[Docket No. CE273; Notice No. 23-07-03-SC]

Special Conditions: Adam Aircraft Industries Model A700; External Fuel Tank Protection During Gear-Up or Emergency Landing

ACTION: Notice of proposed special conditions.

Figure 1 – A700 Side and Front View

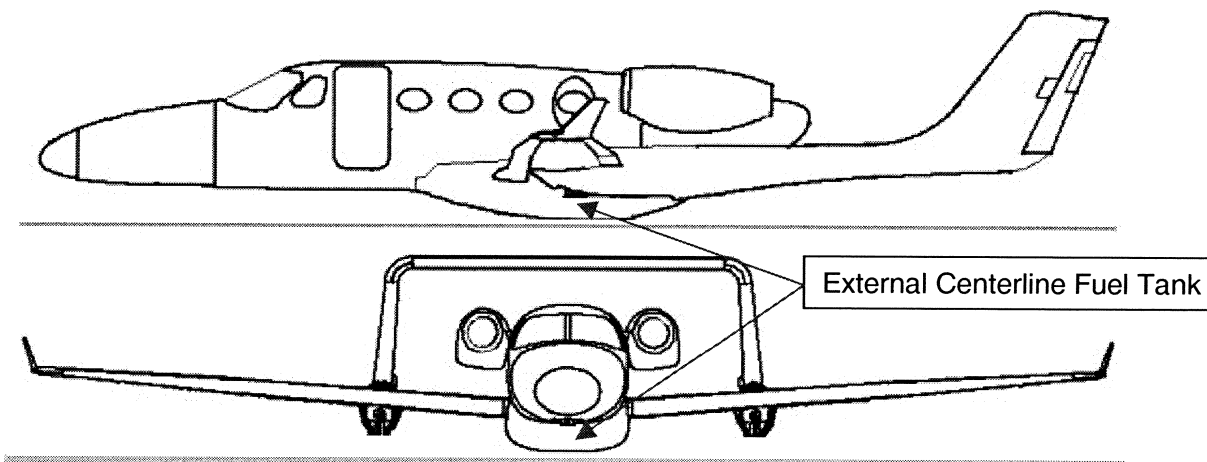
The Adam A700 ECFT is a novel, unusual and a potentially unsafe design feature that may pose a hazard to the occupants during a gear-up or emergency landing due to fuel leakage and subsequent fire. Conventional aircraft construction places the fuel tanks in a protected area within the wings and/or fuselage. Fuel tanks located in these areas are well above the fuselage skin and are inherently protected by the wing and fuselage structure.

The A700 ECFT must meet the inherent qualities associated with the protection of the fuel system as provided by 14 CFR part 23. The FAA requires Adam Aircraft to address the following areas with their ECFT design:

1. *Load Path:* Conventional design approaches establish independent load paths from the keel/skid plate to the airframe major structure where the fuel tanks are isolated from reacting the gear-up or emergency landing loads. The A700 ECFT design must react to the

gear-up or emergency landing loads in a similar manner.

2. *Fuel Management:* Conventional design approaches use fuel tanks located outside of the wings, or wing centerbox, as auxiliary fuel tanks, and not primary fuel tanks. The fuel in the auxiliary fuel tanks is depleted before the primary fuel tanks, thus the auxiliary tanks are usually empty upon landing. In a similar manner, the A700 ECFT must be an auxiliary fuel tank, and not primary fuel tank. The A700 must deplete the fuel in the ECFT before depleting the fuel in the primary fuel tanks.

3. *Location/Geometry:* A700 must preclude the scenario where the fuel tank is the first point of contact with the ground in a gear-up or emergency landing.

1. SC 23.561(c): Each airplane with retractable landing gear and external fuel tank system(s) located beneath the fuselage must be designed to protect each occupant in a landing—

1. With the wheels retracted;
2. With descent velocity of 12.25 feet per second UNLESS mitigating design features are incorporated that address:
 - i. Independent load path
 - ii. Fuel management
 - iii. Location/Geometry
 - iv. Other safety enhancing design features as proposed by the applicant

If adequate mitigation is demonstrated for all the above design features, the FAA will reduce the descent velocity to no less than 5 feet per second.

4. SC 23.XXX: Fuel tanks within and below the fuselage contour must be installed in accordance with the requirements prescribed in Sec. 23.967. External fuel tank system(s) located beneath the fuselage must have the following design mitigations:

1. The external fuel tank system(s) must be in a protected position so that exposure of the tank to scraping action, or impact, with the ground is unlikely during a gear-up landing of the most critical landing gear or landing gears, when landing on a paved runway.

2. The external fuel tank system(s) must be protected by dedicated protective structure, and the protective structure load paths must be independent of the fuel system during a gear-up landing of the most critical landing gear or landing gears, when landing on a paved runway.

3. The hazard to the external fuel tank system(s) that results from impact by landing gear tire fragments or other likely debris must be minimized.

4. The fuel management of the external fuel tank system(s) must be such that fuel in the external fuel tank system(s) is to be emptied prior to fuel in the main tanks.
